January 17, 2013

Re: Updated Work Plan to Evaluate Post-Remediation Site Conditions
Former Petroleum Underground Storage Tank (UST) Site
David D. Bohannon Organization Property Located at
575 Paseo Grande - San Lorenzo, CA

57 Lafayette Circle, 2nd Floor Lafayette, CA 94549 (925) 299-9300/299-9302 (Fax)	FOR: DAVID D. BOHANNON ORGANIZATION 575 PASEO GRANDE SAN LORENZO, CALIFORNIA		PROPOSED SAMPLING LOCATIONS		FIGURE: 10
	JOB NUMBER: 185702534.200.0003	DRAWN BY: RRR	CHECKED BY: JMA	APPROVED BY: CRM	DATE: 12/12/12

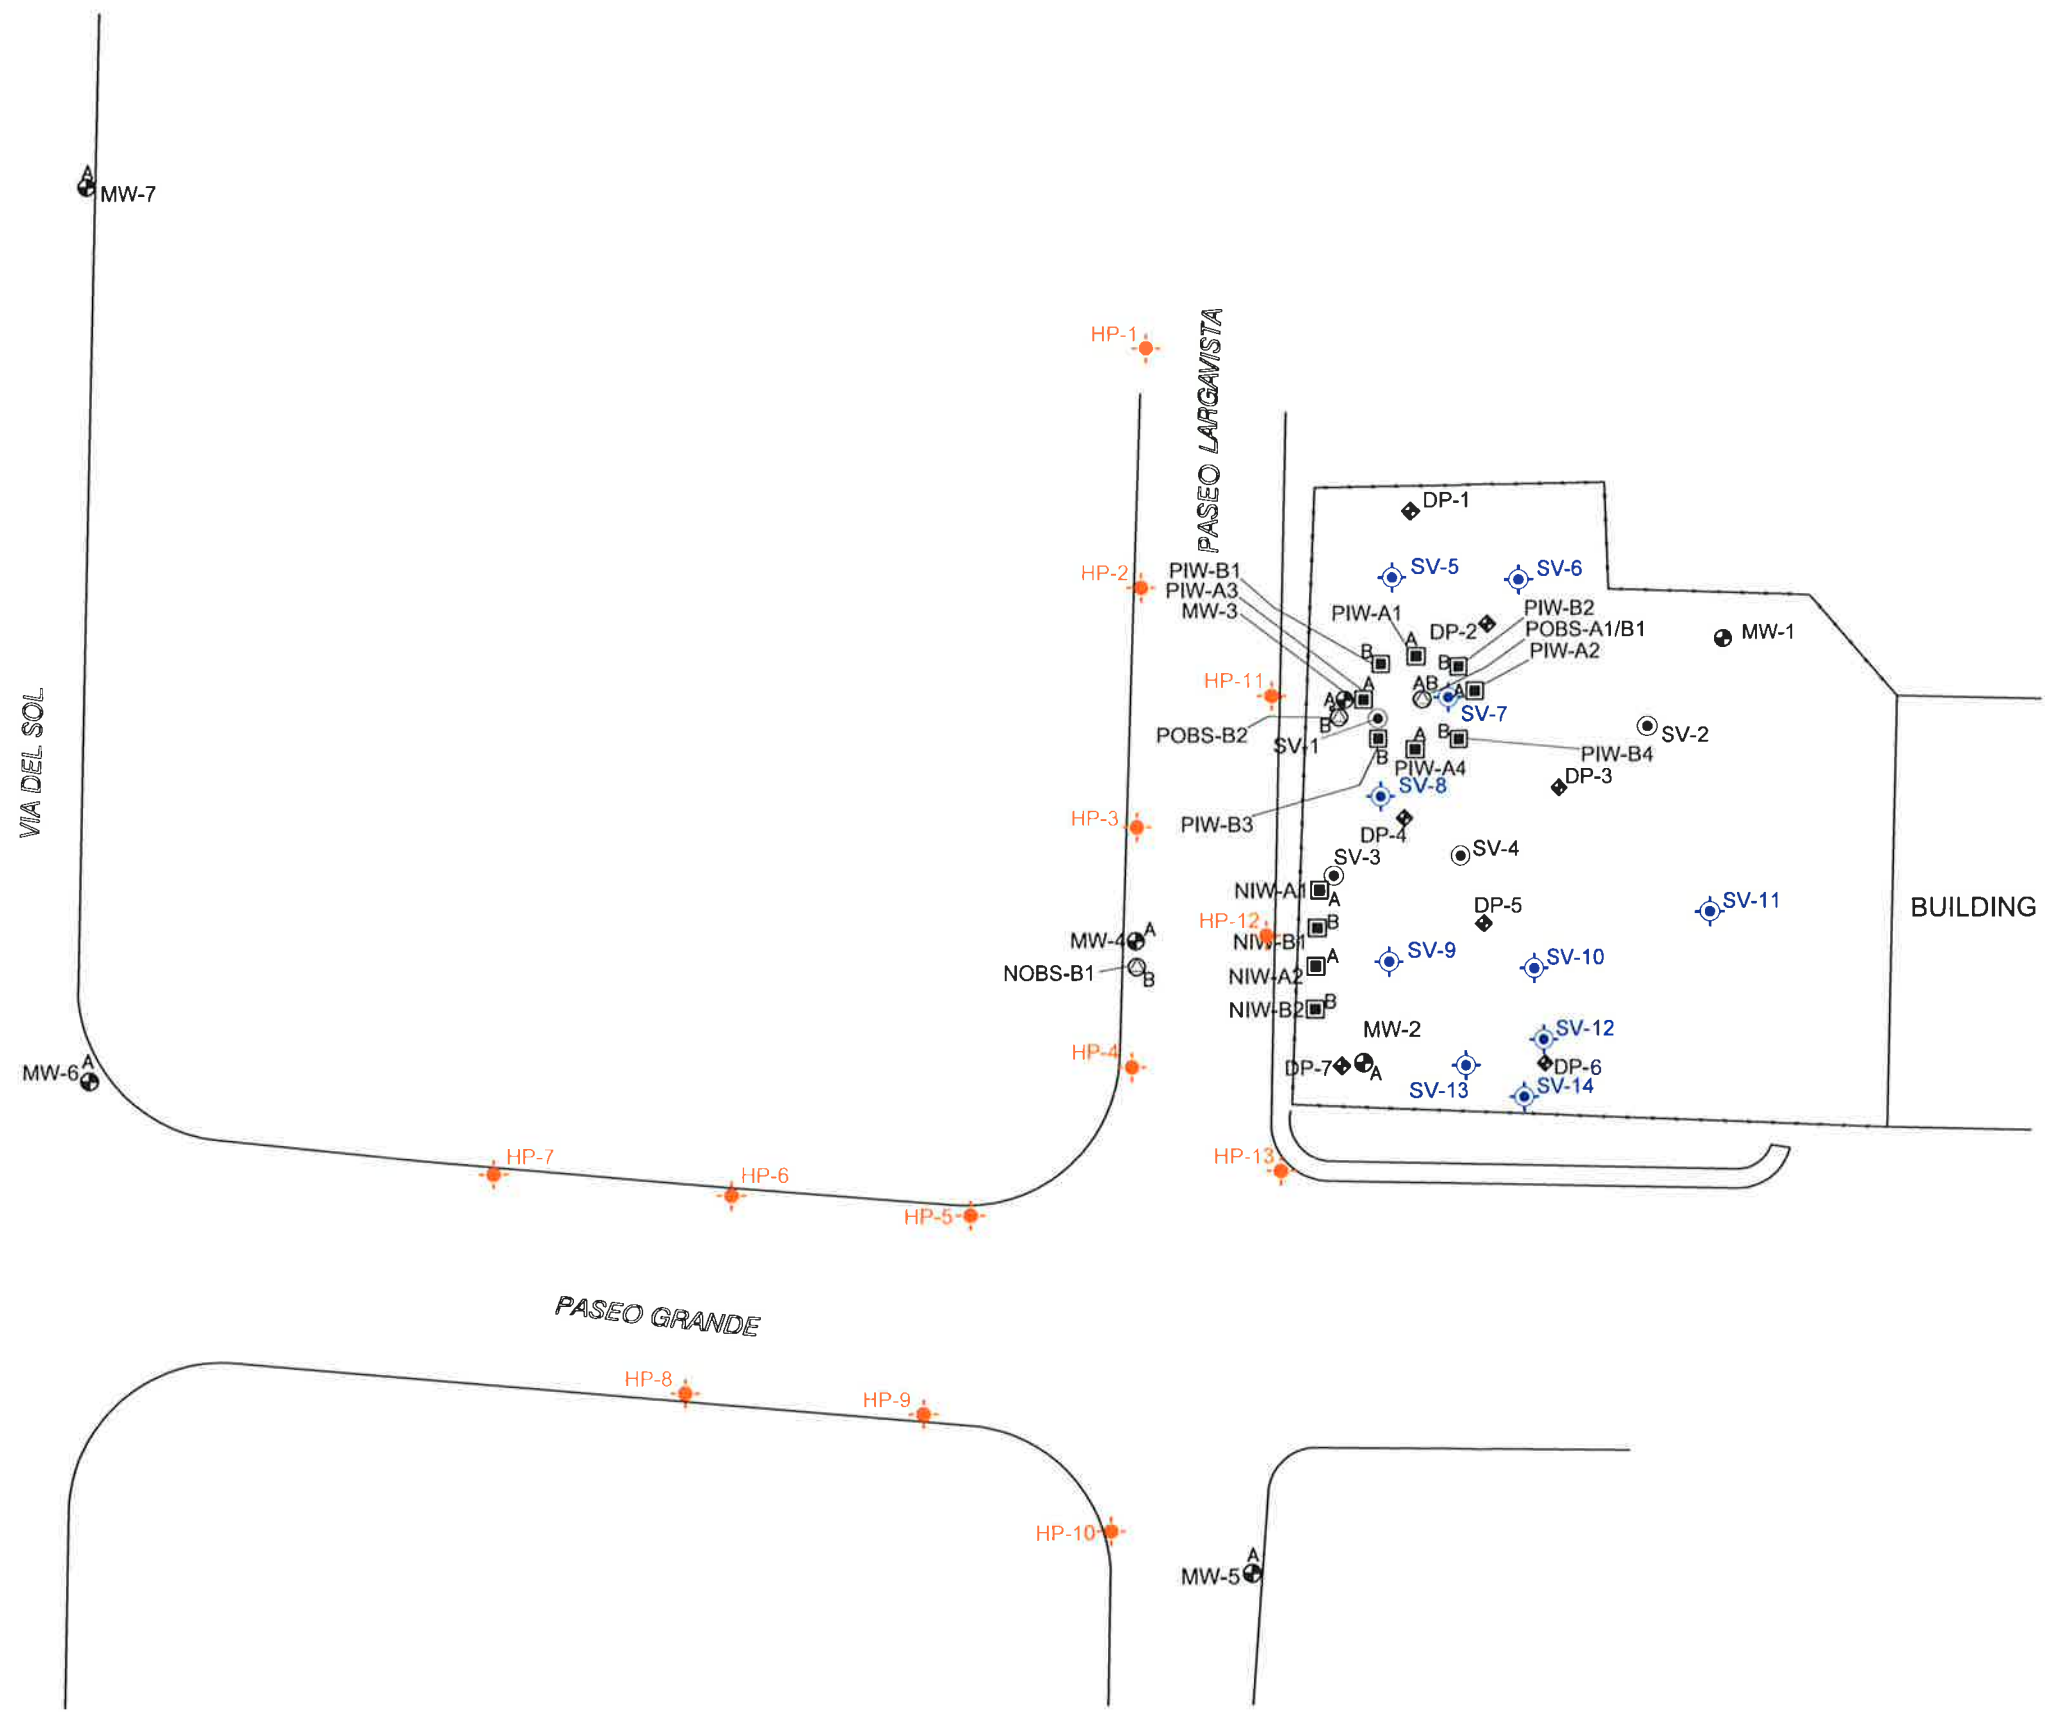
4(c) – Soil Sampling and Analysis – Two soil samples at each on-Site borehole location will be collected for analysis, one in the 0 to 5 interval and one in the 5 to 10 foot interval (see attached updated Figure 10). Samples exhibiting the most elevated photo-ionization detector (PID) readings at each location will be selected for analysis. Soils will be analyzed consistent with the Work Plan, with the addition of those analyses specified in item 4(b) above.

4(d) – Hydropunch™ Soil Bore Installation – Grab groundwater sampling utilizing the Hydropunch™ methodology will be completed in the shallow water bearing zone (i.e., the upper 15 feet of sediment). The spacing between sampling locations will be approximately 50 feet (see attached updated Figure 10).

4(e) - Hydropunch™ Sampling Locations - An additional transect of three (3) locations has been included on the east side of Paseo Largo Vista (locations HP-11 to HP-13; see attached updated Figure 10). The grab groundwater sampling depth and methodology at these locations will be consistent with the scope of work presented in the Work Plan. Additionally, soil sampling will be conducted at each of these three (3) locations. Three (3) samples will be collected at each location, with one sample collected in each of the 0 to 5, 5 to 10, and 10 to 15 feet bgs depth intervals. Sampling and analysis will be consistent with the methods described in the Work Plan, including using the PID for sample collection as described in item 4(c) above and the naphthalene analysis presented in item 4(b) above.

With regards to the sampling locations presented on the attached updated Figure 10, please note the locations are approximate. Actual locations, particularly off-Site, may be modified upon review of potential access restrictions including the presence of overhead and underground utilities.
